Metro Inner Development Assessment Panel Agenda

Meeting Date and Time: Wednesday, 6 May 2026; 9:30am
Meeting Number: MIDAP/131
Meeting Venue: 140 William Street, Perth

- 3.1 Lots 37 & 36 (Nos. 29 & 31) Davilak Street, Como – Ten Grouped Dwellings – DAP/25/03029

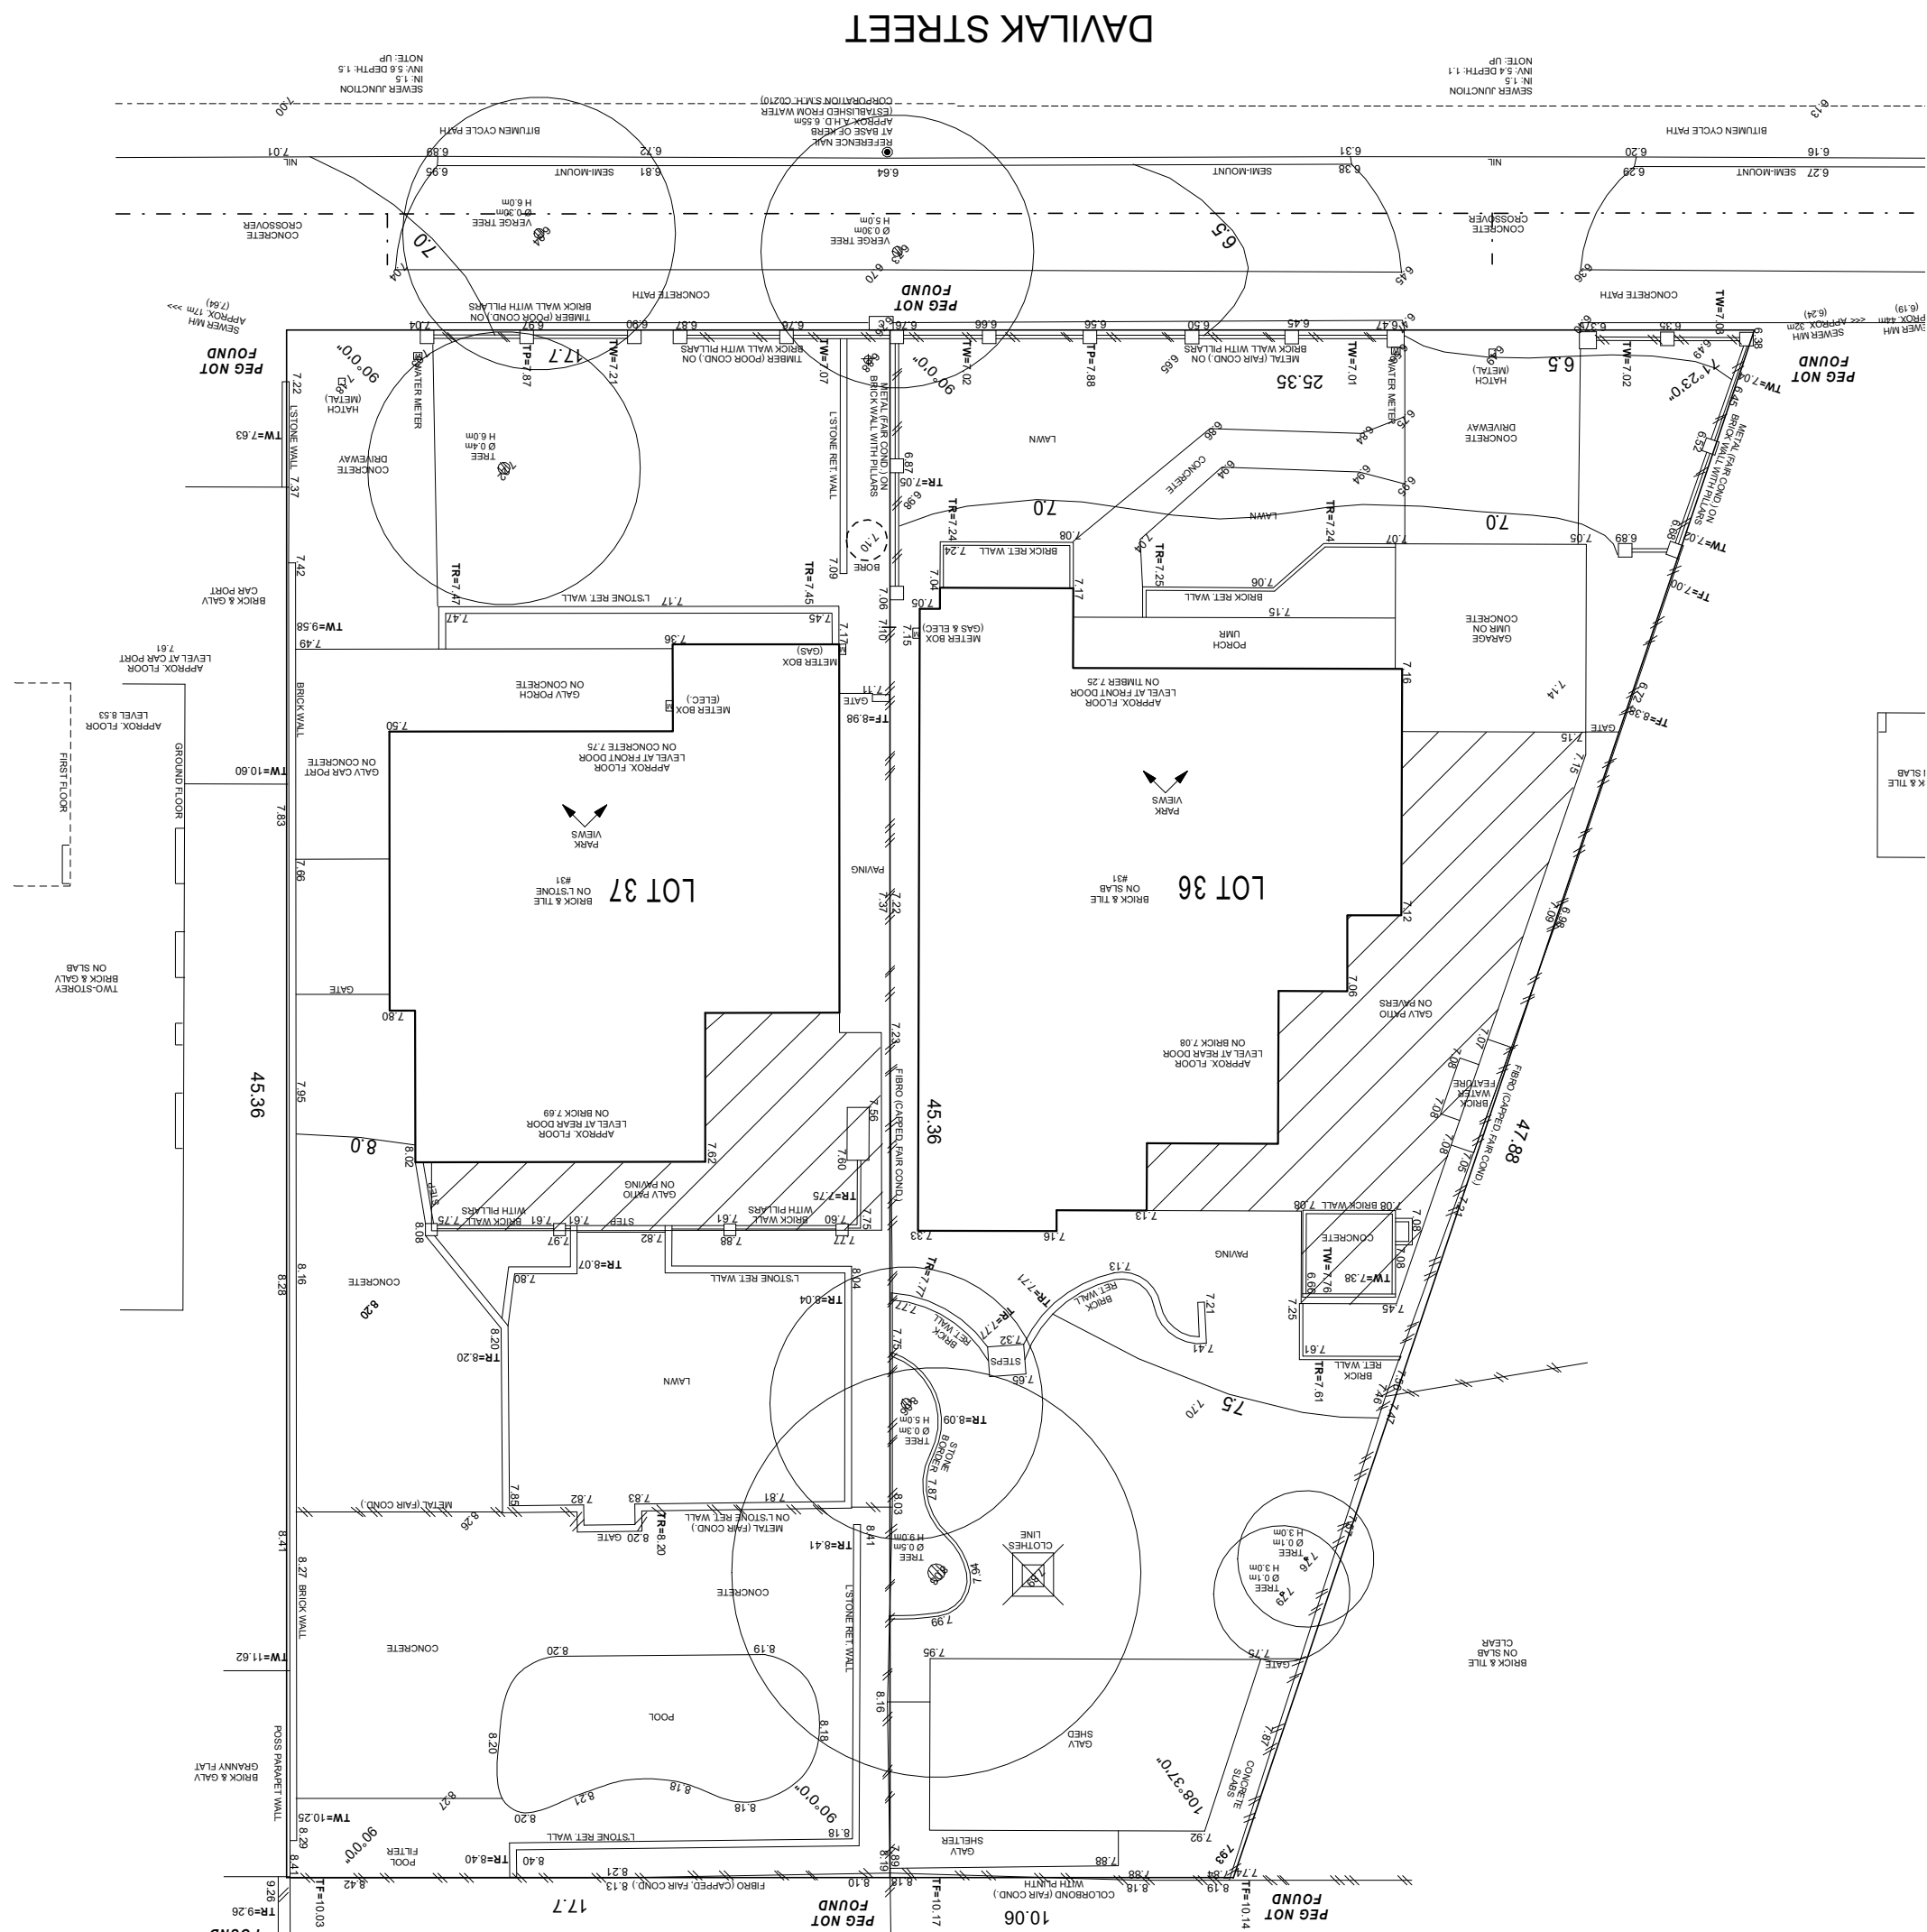
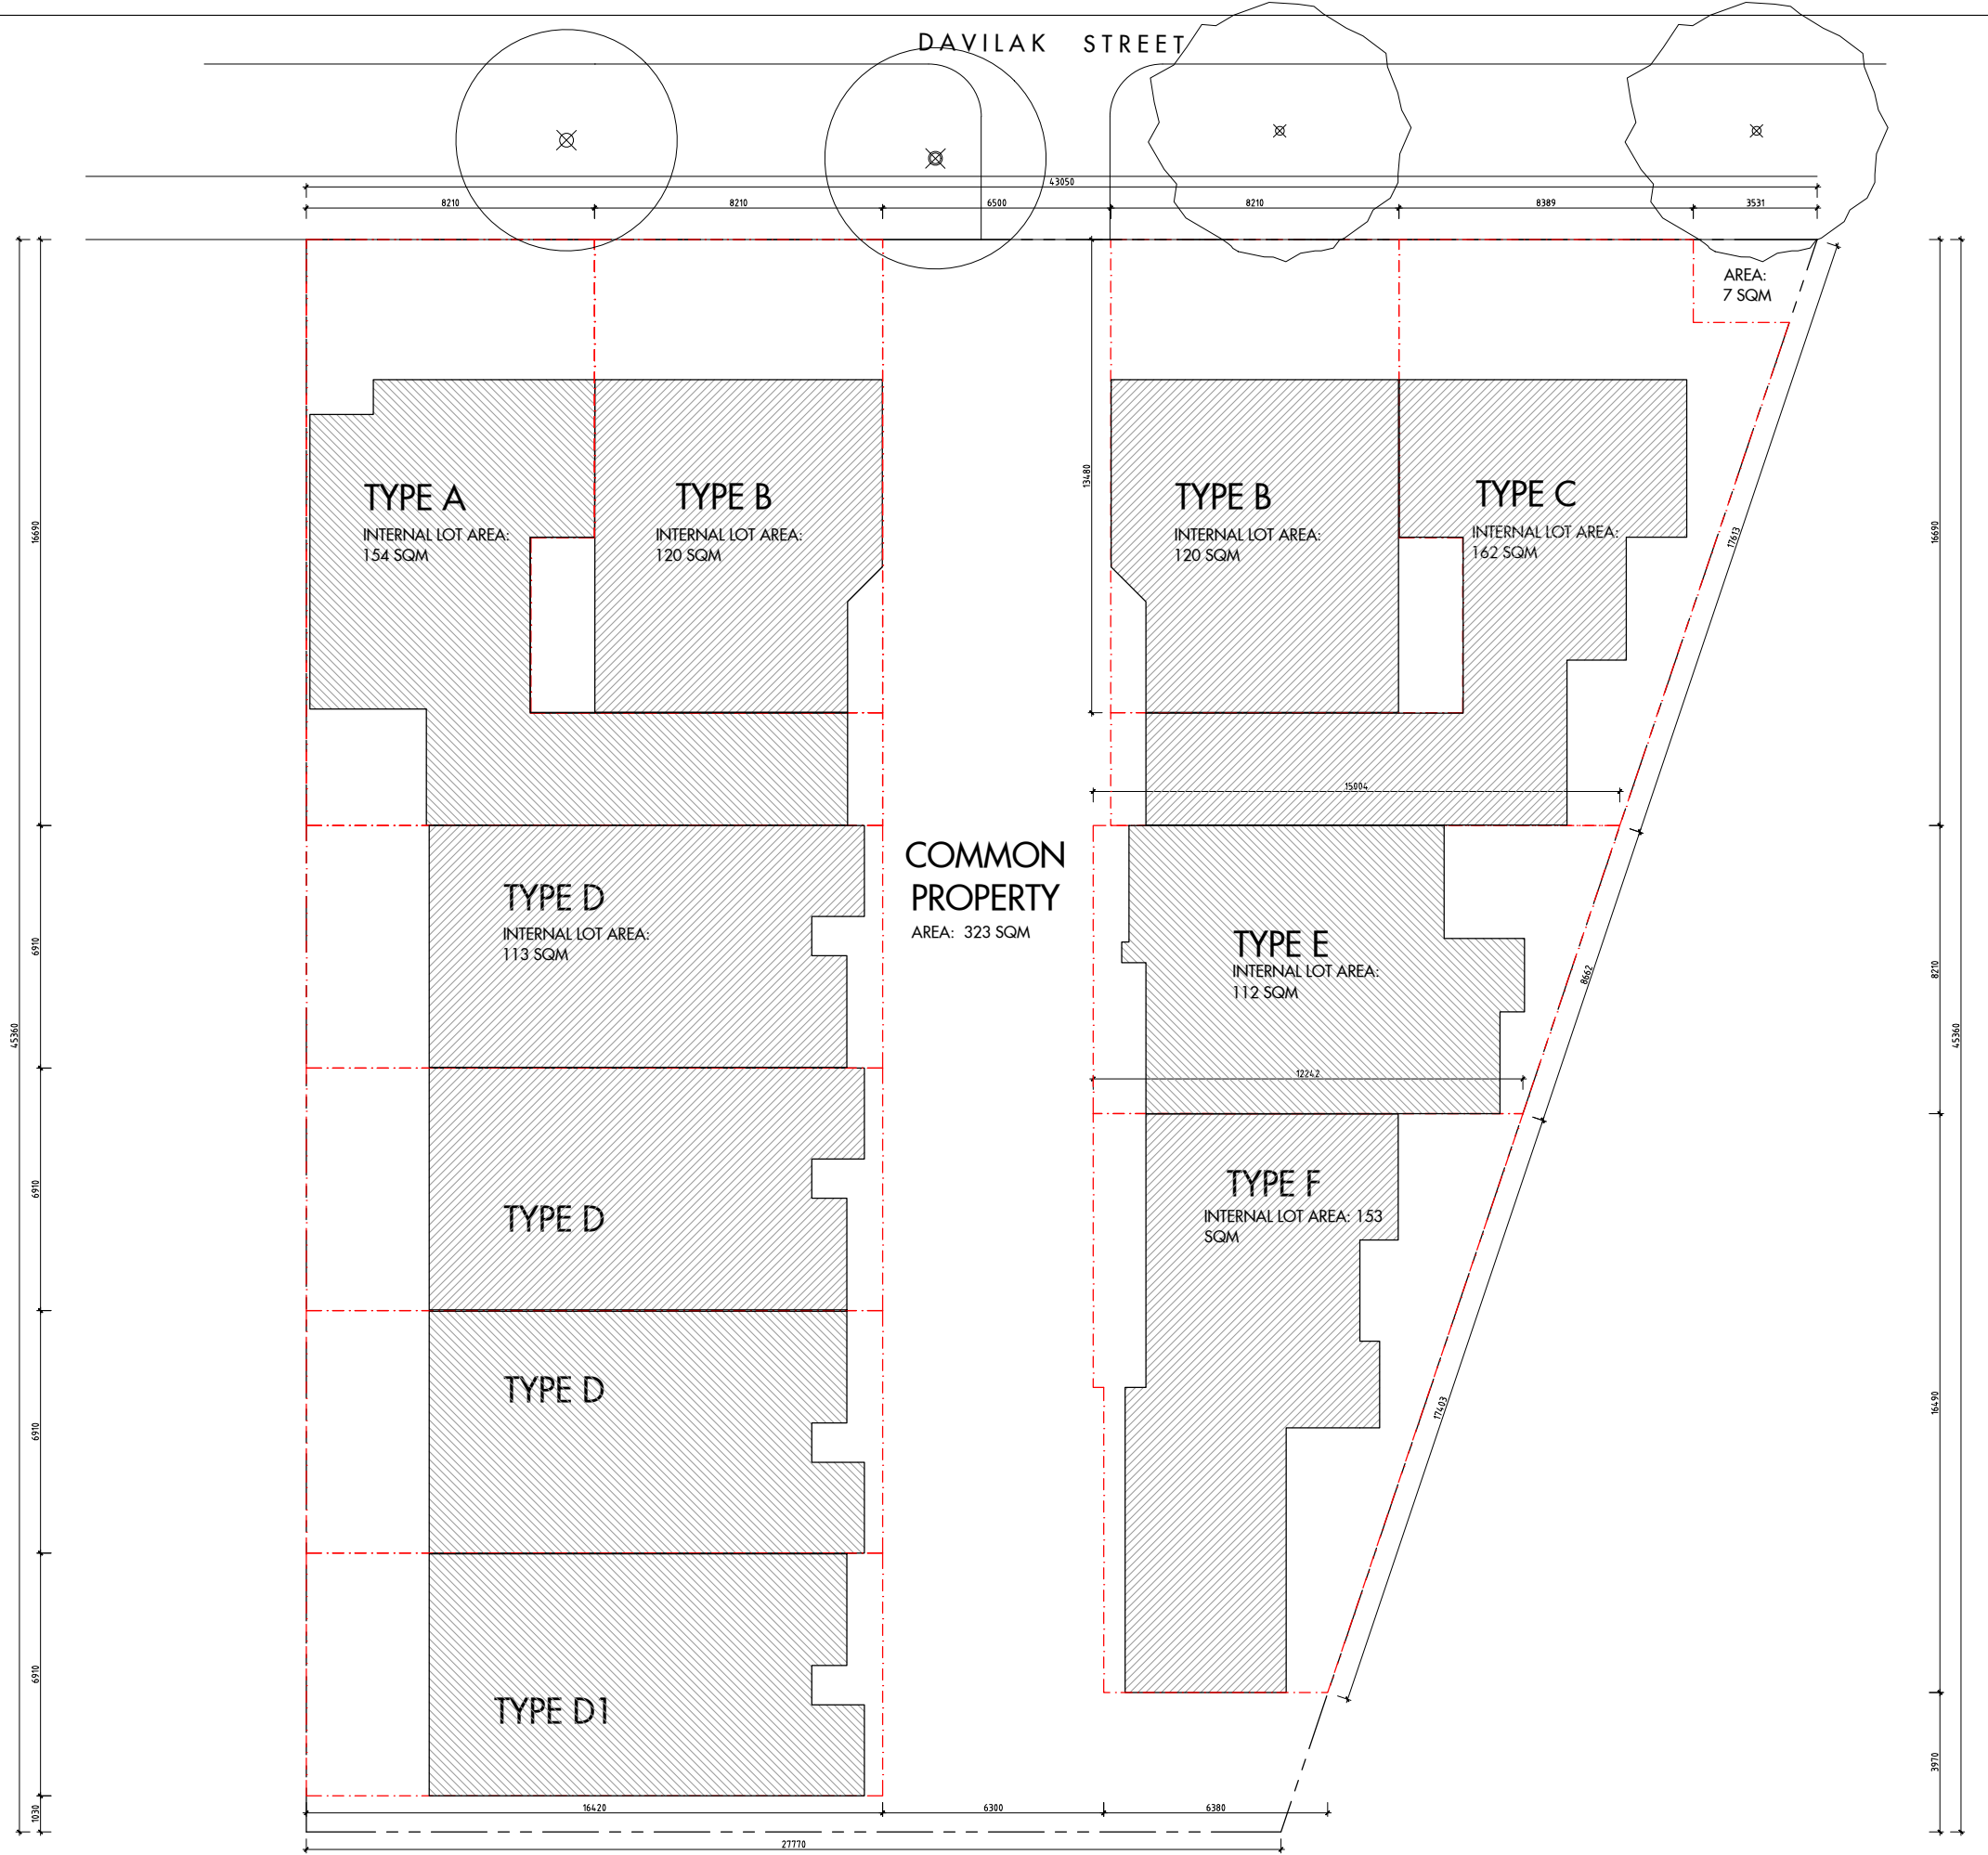
- The wall presents as an independent element of the design rather than being integrated with the development and is considered to be unnecessarily long.
- The City considers design should ensure utilities are not visually obtrusive. Any solid walls housing utilities should be no longer than 1.0m and aligned perpendicular to the street, neither of which are met in the current proposal.

To address the above concerns, a condition has been included in the City's recommendation for amended plans addressing the impact of the proposed solid wall.

- (a) Type E bedroom 3 achieving a minimum dimension of 2.9m and minimum area of 9.0m² excluding robes and built-in cabinetry.
 - (b) The design of the solid 1.8m high street wall in the north-east corner of the site shall be revised to address adverse visual impacts to the streetscape associated with blank walls and visually prominent location of utilities.
